March 29, 1990
NLR-N90055
LCR 90-05

**INCREASE TO ALLOWABLE MSIV CLOSURE TIME
LICENSE AMENDMENT APPLICATION
FACILITY OPERATING LICENSE NOS. DPR-70 AND DPR-75
SALEM GENERATING STATION UNITS 1 AND 2
DOCKET NOS. 50-272 AND 50-311**

FIGURE 1

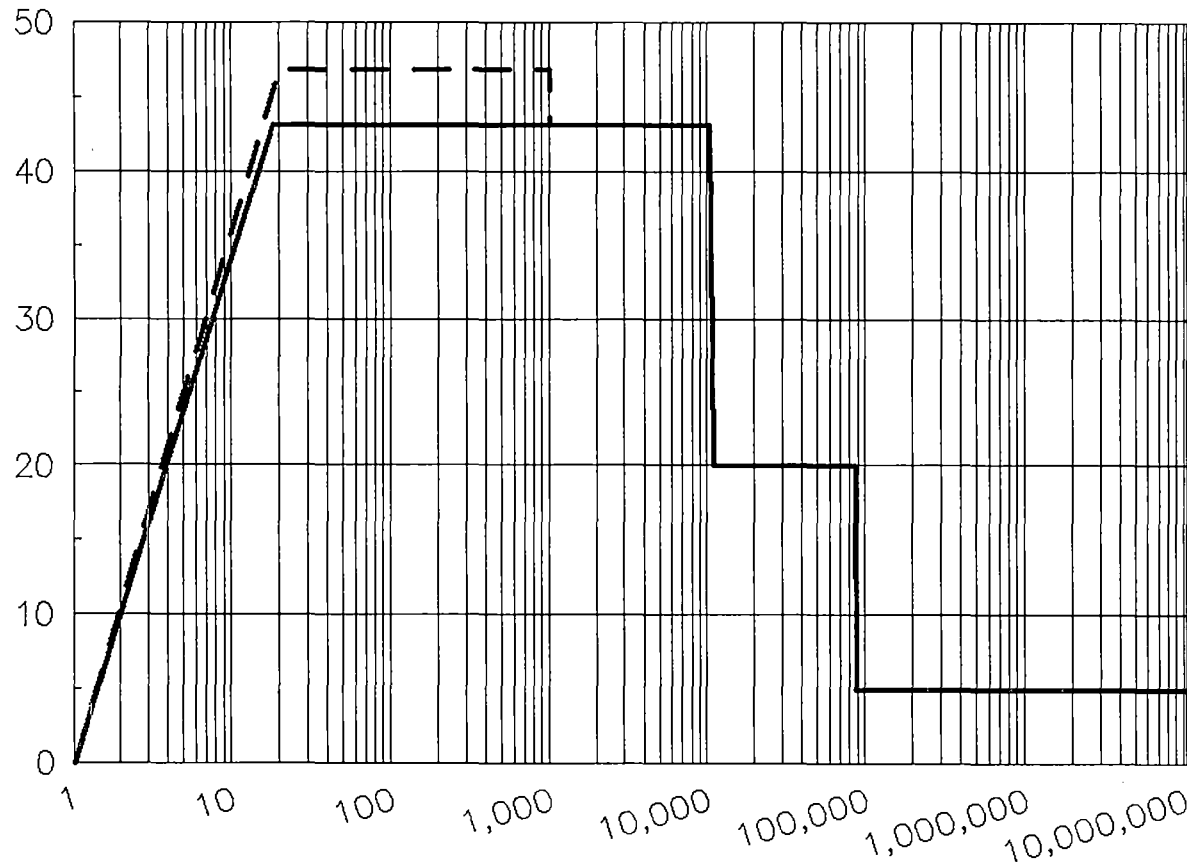
As discussed above, the expected limiting MSLB cases in terms of peak containment pressure have been reanalyzed to support the proposed increase in MSIV closure time. As demonstrated by Figure 1, the resulting pressure curve exceeds the current envelope of the Salem Generating Station Environmental Qualification program (EQ program). The increased pressure has been evaluated against the applicable vendor qualification test reports. Review of the vendor data indicates that the lowest qualified pressure for the affected safety related equipment inside containment is 60 psig, which is above the new peak pressure of 46.9 psig.

FIGURE 2

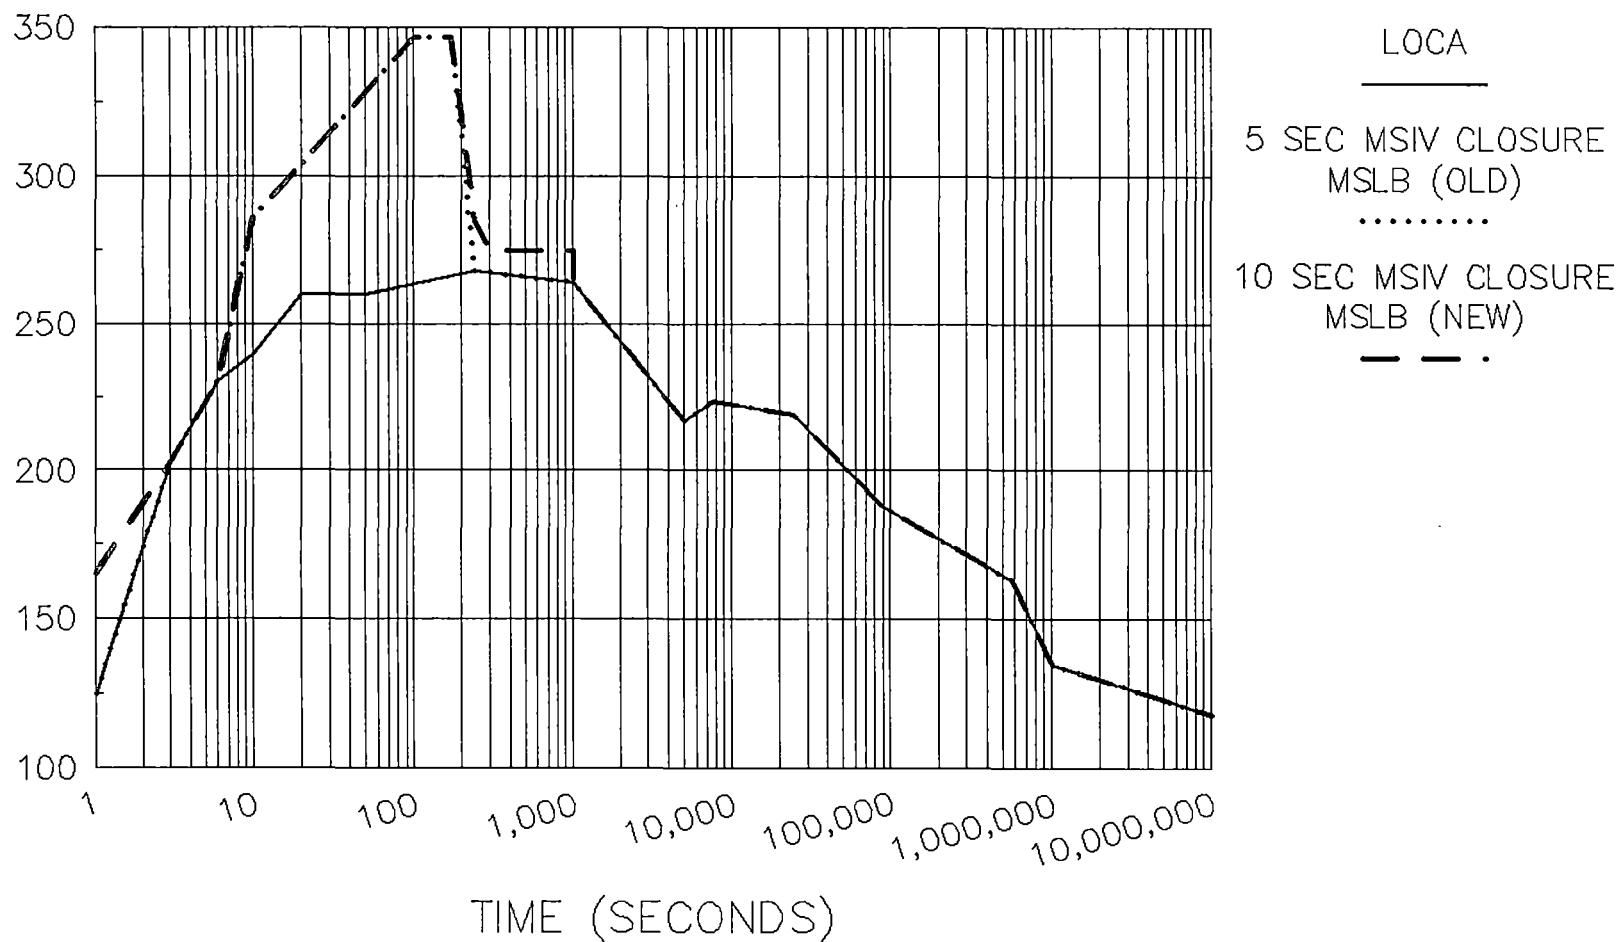
With regard to containment temperature, a revised profile was developed based on the MSLB cases that have been reanalyzed. A comparison of the revised and current MSLB/LOCA profile is shown in Figure 2. All of the remaining unanalyzed MSLB licensing basis cases have been evaluated for the impact of increased MSIV closure time on the containment temperature profile. The results of this evaluation indicate that the containment temperature response for the entire spectrum of steam line break cases, using a 10 second MSIV stroke time, is expected to be bounded by the revised containment temperature envelope of Figure 2.

Figure 2 shows two time periods where the existing EQ program temperature profile is exceeded. The first region is in the initial temperature rise. Because of the short time duration of the exceedance, only equipment surface temperature is affected, and not the temperature of the internal components. Therefore, this increase has a minimal effect on the EQ program.

FIGURE 3

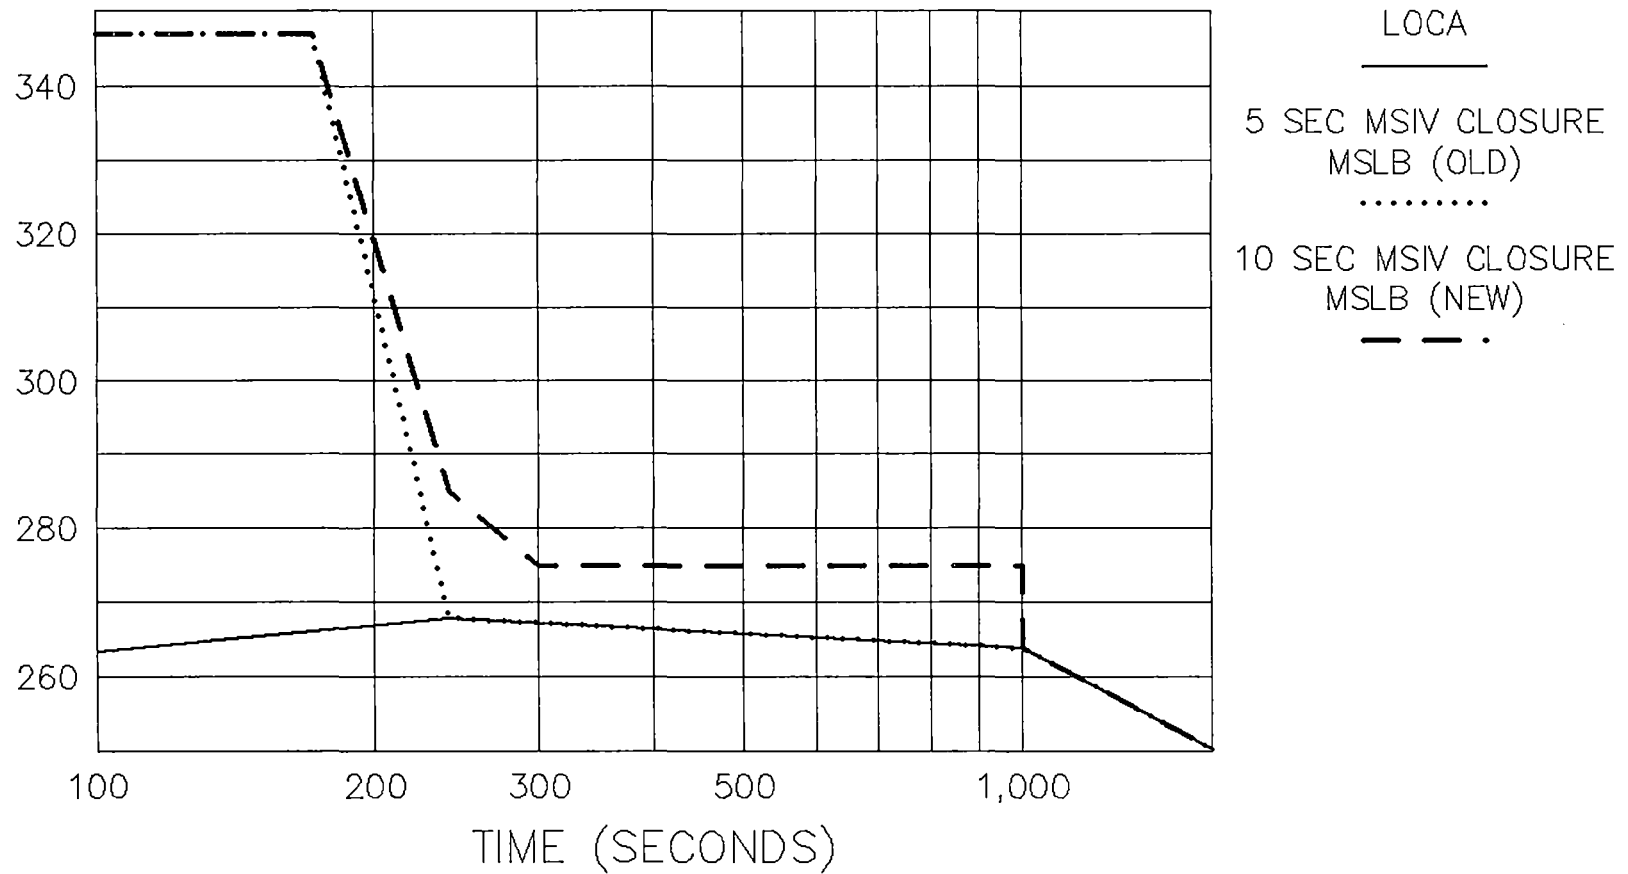
The second region of exceedance is in the 240 to 1000 second time period (Figure 3 contains a detail of this region). Although the temperature profile has increased from 264 to 275 degrees F, a combination of test data and temperature lag analysis have demonstrated that the qualification of the affected equipment is being maintained in accordance with 10CFR50.49. The documentation comprising the EQ program will be updated pending NRC approval of this change request.
